AGENDA
CHARTER TOWNSHIP OF MERIDIAN
ENVIRONMENTAL COMMISSION
JOINT COMMISSION MEETING AND
REGULAR MEETING
July 10, 2019 7:00 pm

3. APPROVAL OF THE AGENDA
4. APPROVAL OF THE MINUTES
5. PUBLIC REMARKS
6. NEW BUSINESS
 - a. Wetland Permit Application: Central Meridian Trail Connector
7. OLD BUSINESS
8. CHAIR'S REPORT
9. STAFF REPORT
10. COMMISSION/LIASON/WORKGROUP REPORTS
 - A. Planning
 - B. Land Preservation
 - C. Energy
 - D. Brownfield Redevelopment Authority
 - E. Green Team
 - F. Transportation
11. PUBLIC REMARKS
12. ADJOURNMENT

PROJECT	CENTRAL MERIDIAN REGIONAL TRAIL CONNECTOR MERIDIAN TOWNSHIP INGHAM COUNTY, MICHIGAN
APPROVED	DBH
CHECKED	DBH
DRAWN	HTR
JOB NO.	18-0066
DATE	4/18/2019
SCALE	AS NOTED
SHEET NO.	C2.0

JOB NO. 18-0066
 DATE 3/18/2019
 SCALE AS NOTED
 SHEET NO. C3.0

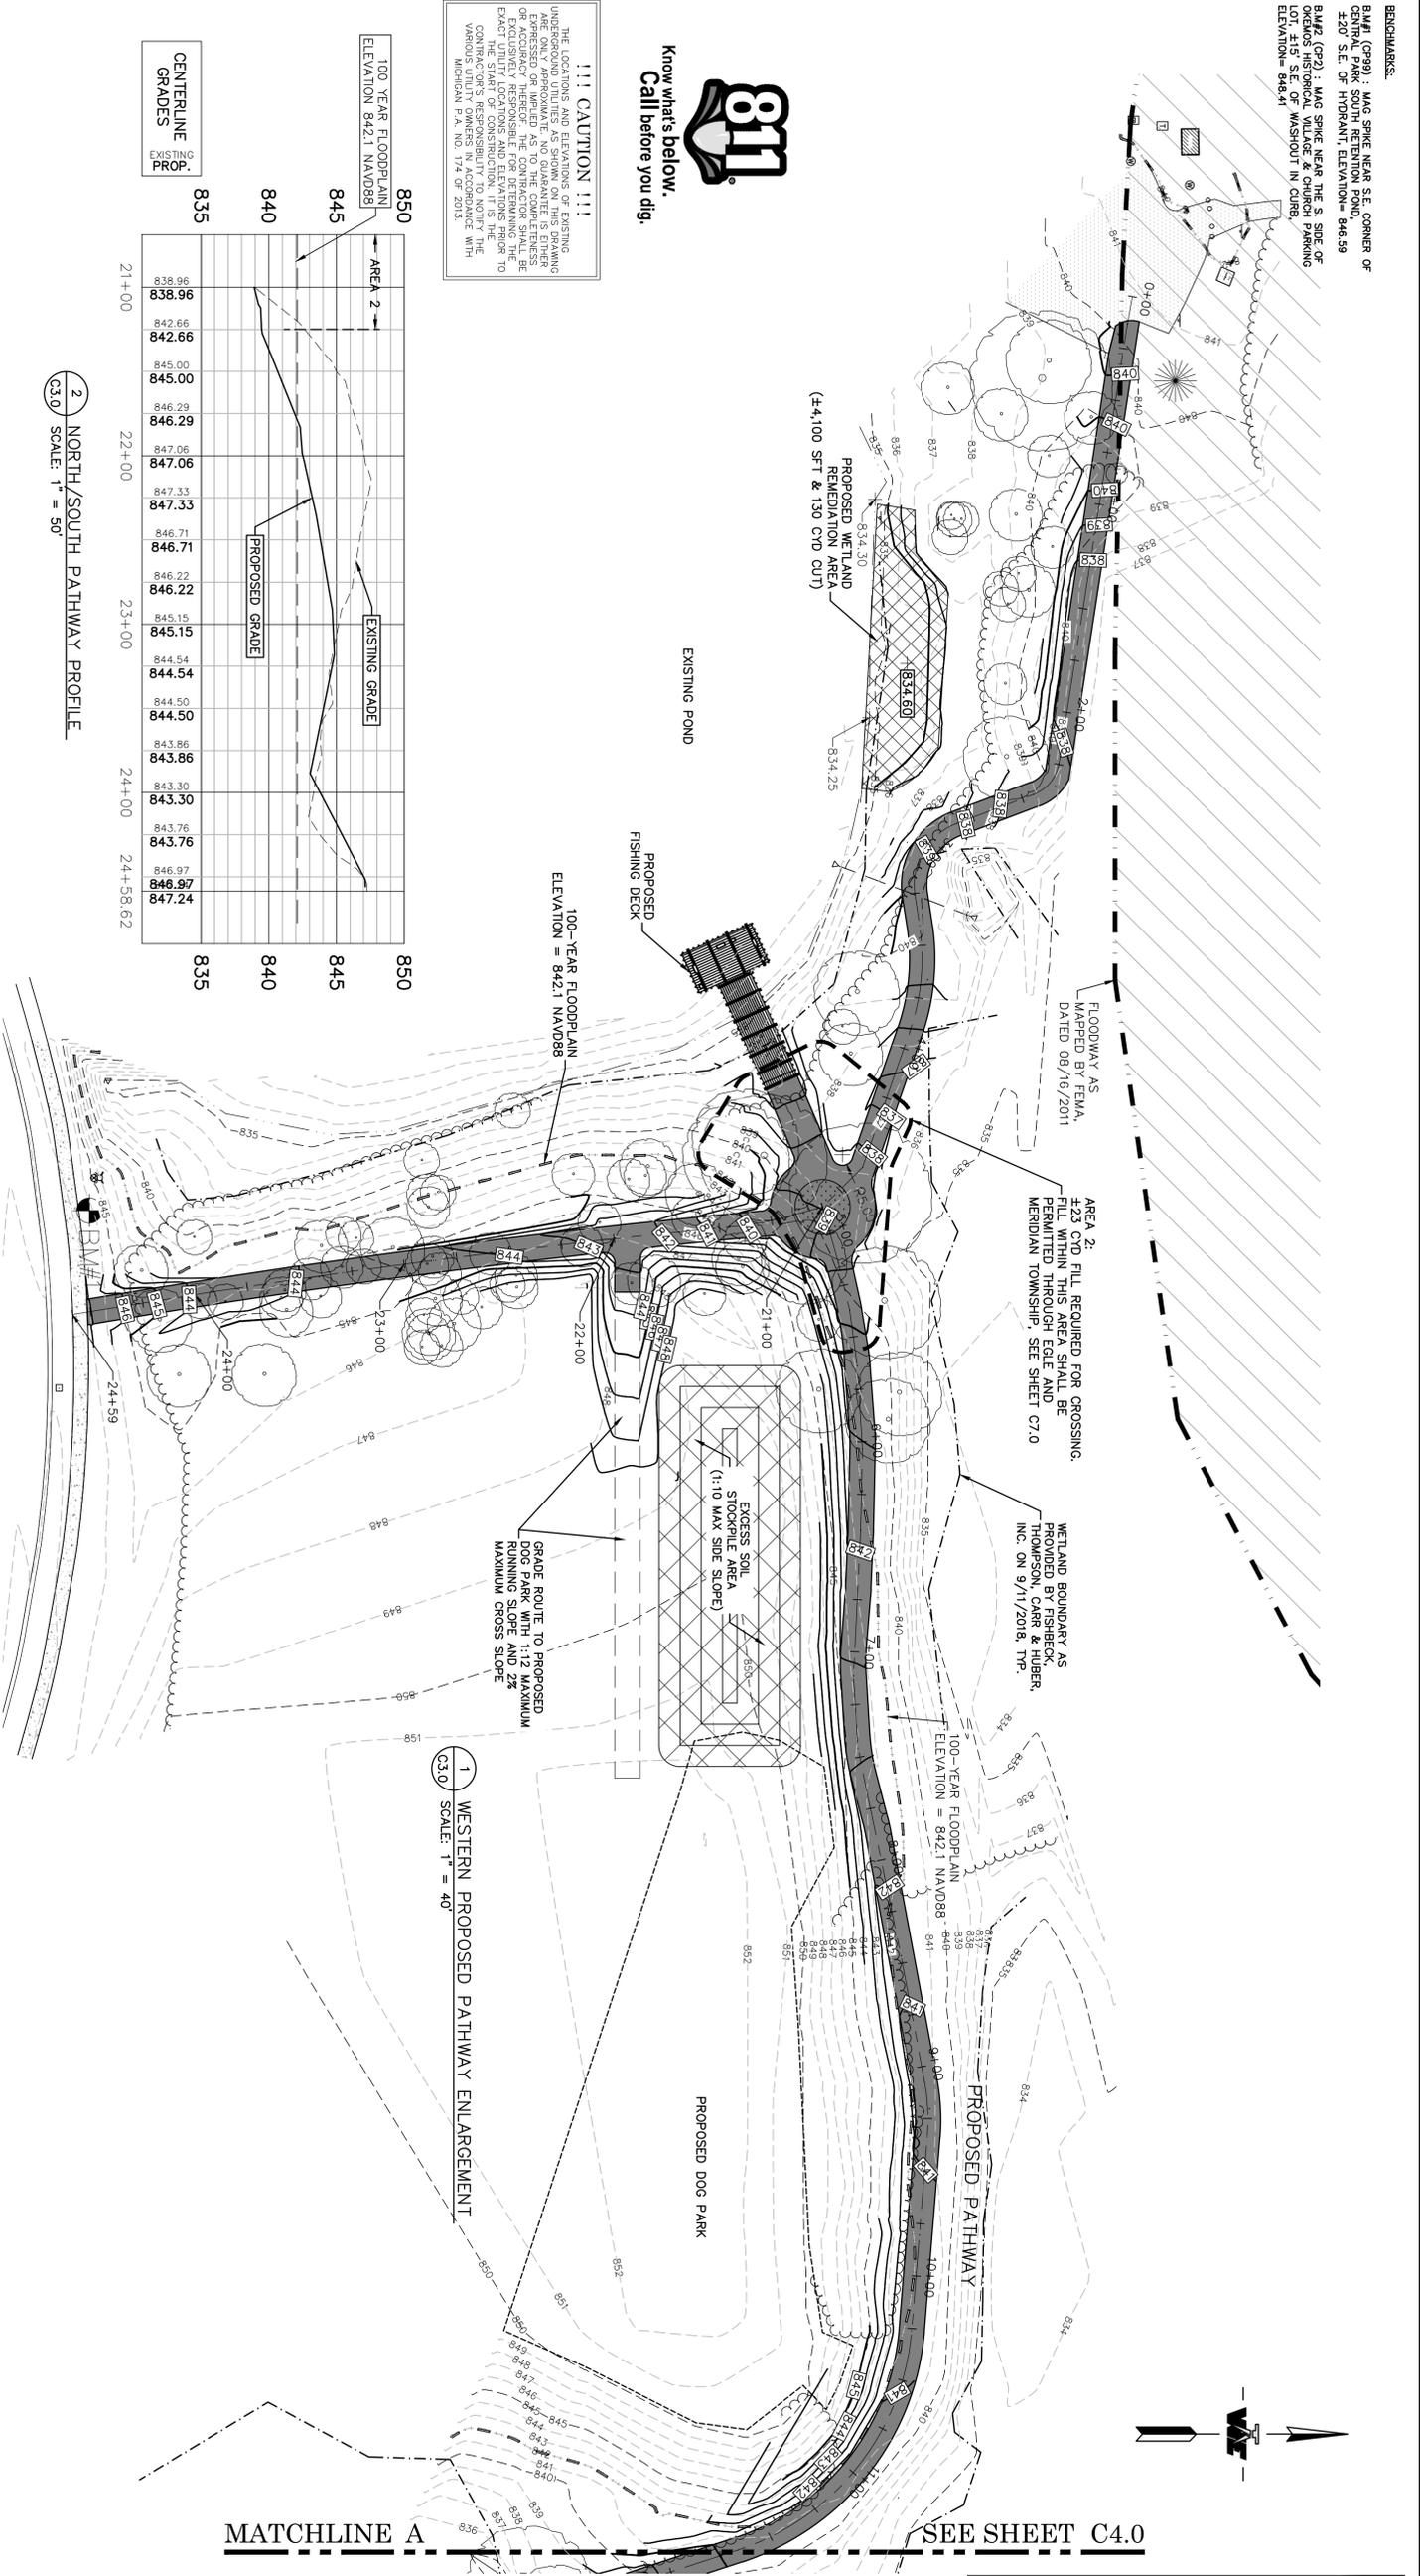
1. Construct a mitigation wetland on the north shore of the site's pond, as indicated on Sheet No. C3.0 of the project plans. The mitigation wetland must be at least 2,745 square feet in size to compensate for filled wetland at a ratio of 1.5:1. The mitigation wetland should consist of emergent wetland.

JOB NO.	18-0066
DATE	11/12/18
SCALE	1" = 40'
SHEET NO.	C4.0

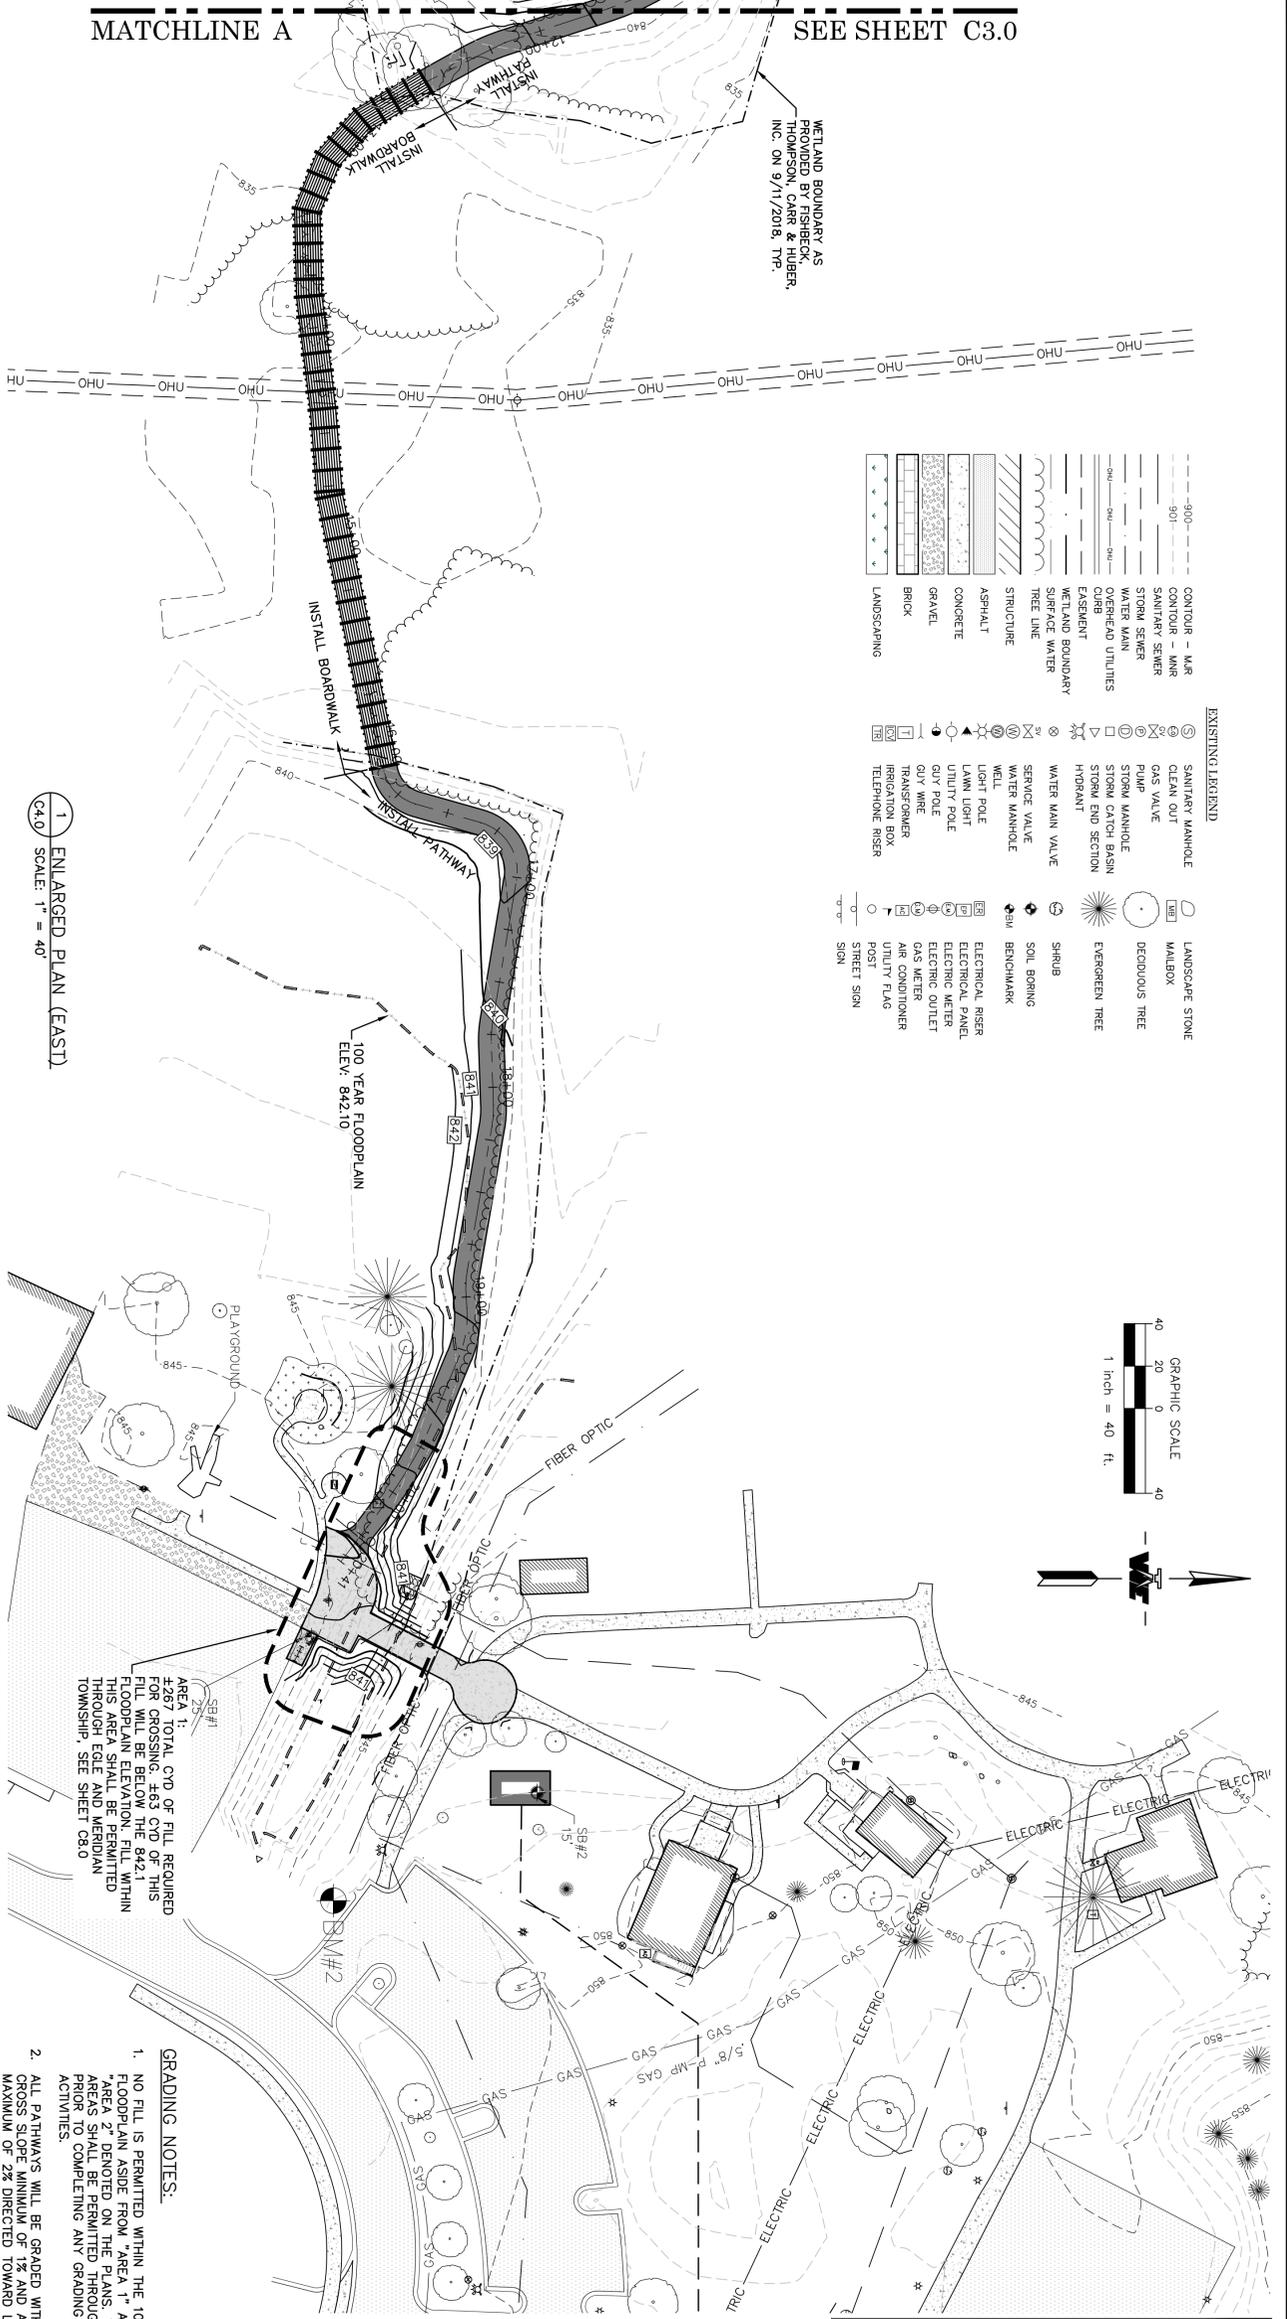
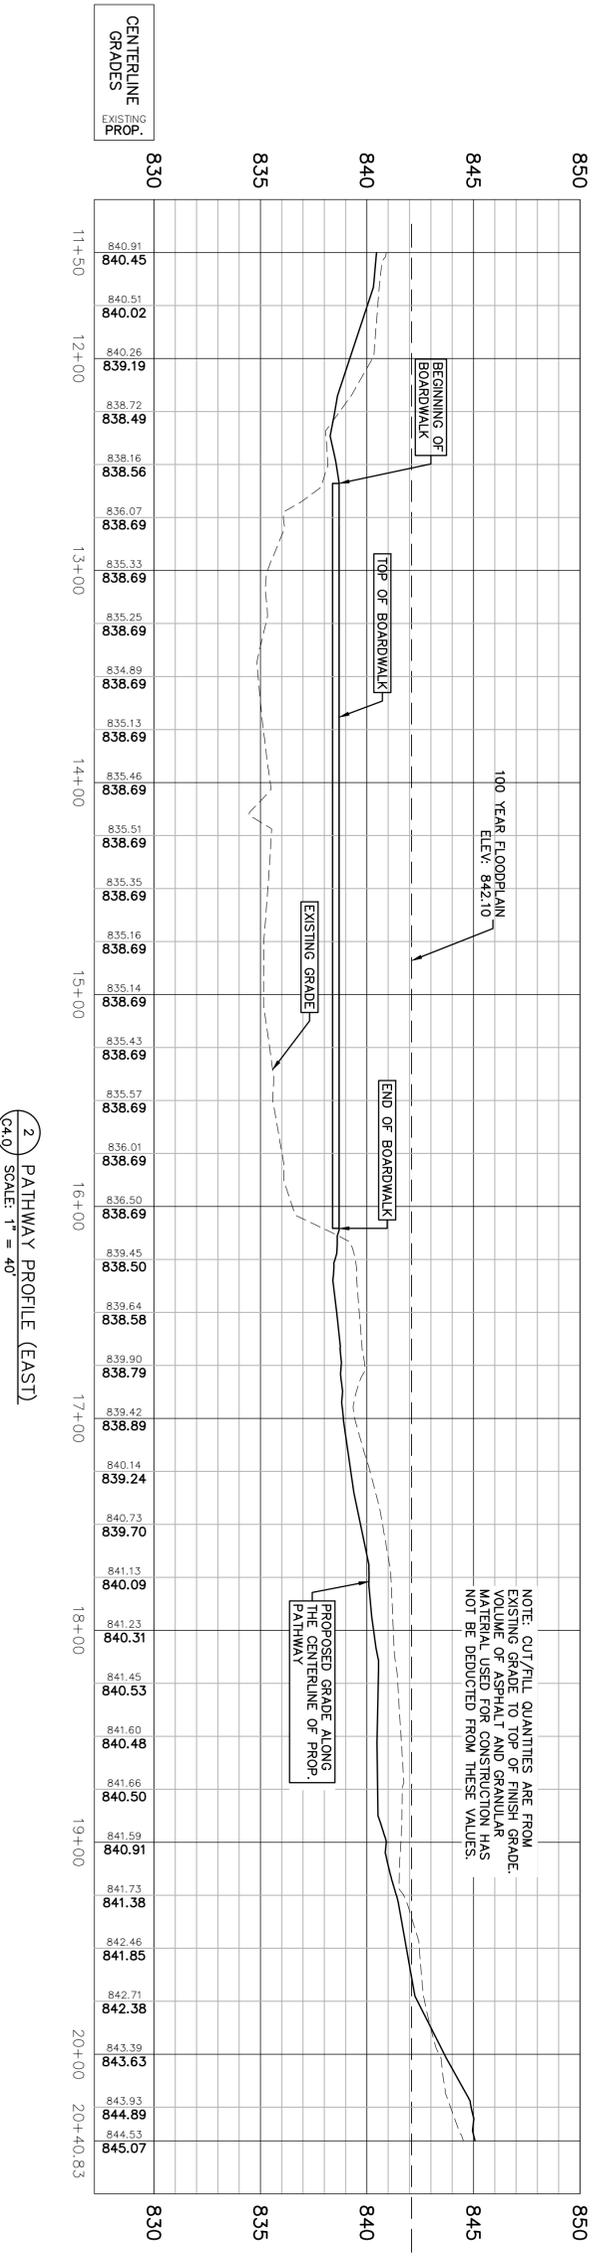
Clarify plan table on sheet C4.0

The plan table shows 1173.63 cy of cut and 1260.80 cy of fill, however it is unclear if these volumes pertain to flood plain only or flood plain and wetland combined. Please update the plan table to show the volumes associated with Part 31 and Part 303.

Table has been removed from plans as it related to cut and fill for the entire project and not just work within floodplain/wetland areas. Please see "Correction request statement" and notes/cross-sections shown on sheets C7.0 & C8.0 for additional cut/fill information.
